ATR on Quality Control Check Report. (Bungalows)

Quality Control Check Report Stage: Before Casting Slab (Villas)

V. No : 150
Slab - 01

Description QUALITY CONTROL SLAB CHECK PLAN TYPE-BB2	Direction 	Owners & Developers:	Date:	01.02.2017	Promoted by:
		Modi & Modi Constructions	Prepared By:	Nagalaxmi	Modi Properties &
		Project Name & Phase:	Approved By:	Soham Modi	Investments Pvt. Ltd.
		Nilpan Estates	Scale:	N.T.S	Phone: +91-40-66335551

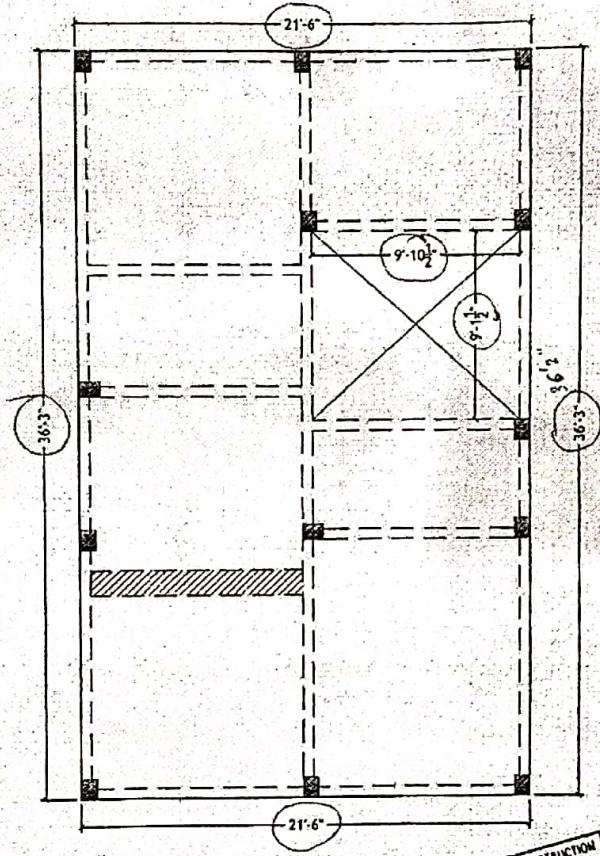
Remarks: Note 1. Shuttering and Rod Bending work should be improved

2. Couple of places covering blocks for slab & beam not provided

1) All works are completed.

Certified that all corrections mentioned in the QC report have been completed. Work can proceed to next stage.
